Validation and Verification Report:

Name of Verification company:	Date of the issue:
Scientific Certification Systems (SCS)	August-31-11
Report Title:	Approved by:
Validation and Verification Report – Infapro Improved Forest Management Project	Todd Frank
Client:	Project Title:
Face the Future	INFAPRO Rehabilitation of logged-over dipterocarp forest in Sabah, Malaysia
Summary:	
This report documents the validation and verification of the Infapro Improved Forest Management project against the Verified Carbon standard 2007.1 and its supporting documents, including the approved methodology VM0005 Version 1.0 Methodology for Improved Forest Management: Conversion of Low Productive to High Productive Forest. The validation activities included desk review of project design documentation and supporting documents, a field visit to the project area, interviews with relevant personnel, re-measurement of forest carbon plots, and review of calculations of the project's net carbon benefits. The project seeks to rehabilitate approximately 25,000 ha of severely logged-over mixed dipterocarp rainforest in Sabah, Malaysia and prevent the relogging of the forest in this area. The review of Project d

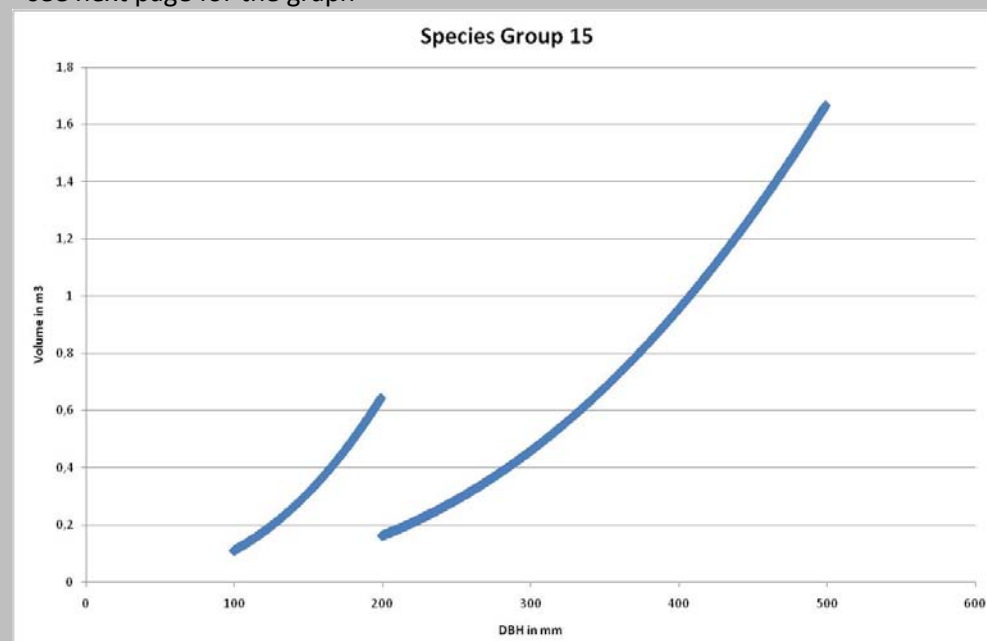
Finding: Because equations given in Table 4.3.2.1 of the methodology-PD* are not applicable for small trees, the project applies a different equation for trees in the DBH category of 5 to 10 centimeters. However, this range is not sufficient to limit the use of the equations reported in table 4.3.2.1 to the range of diameters for which they are applicable, as illustrated by the included figure(see file Allometry_bias_example.jpg). The range for which each allometric equation is applied must be re-evaluated to ensure the resulting biomass estimates are unbiased.

Proponent Response: The project proponents did not realize at the time that the issue was raised during the audit, that the deviation in carbon stock for the trees in the dbh class 10-20 cm was caused by the plot expansion factor. After a closer analysis of the data in the spreadsheet, the true cause of the 'bias' was noticed. The equations used for calculating the volumes and the carbon stocks for trees larger than 10 cm were reassessed. The reason for the bias for trees in the dbh range of 10 to 20 cm appears to be related to the application of an expansion factor, rather than the inapplicability of the equations for this dbh class. The trees in the dbh class 10 - 20 cm are measured in the first circle of the plot - i.e. in 500 m² of the total plots size of 2,000 m². In order to upscale the value of these trees to the whole plot, an expansion factor of 4 has been applied. In the spreadsheets with the tree data, the volume and carbon per tree is already multiplied with the expansion or scaling factor.

The graph below illustrates this for species group 15, which includes the species Ampas tebu (AMPT) that was used as an illustration for showing the bias. The diameters 10 to 50 cm are included in the graph. If the volumes for the trees in dbh class 10 - 20 cm are divided by 4, the graph will smoothly continue from this dbh class to the larger diameters in a continuous line.

Auditor Response: The auditor conducted an independent analysis of the equations applied and confirmed that the issue addressed in the finding resulted from a misunderstanding by the auditor of the way the expansion factor had been incorporated into analysis. Each of the allometric equations were graphed to ensure that the cutoff point for applying the small tree equation was not on the wrong
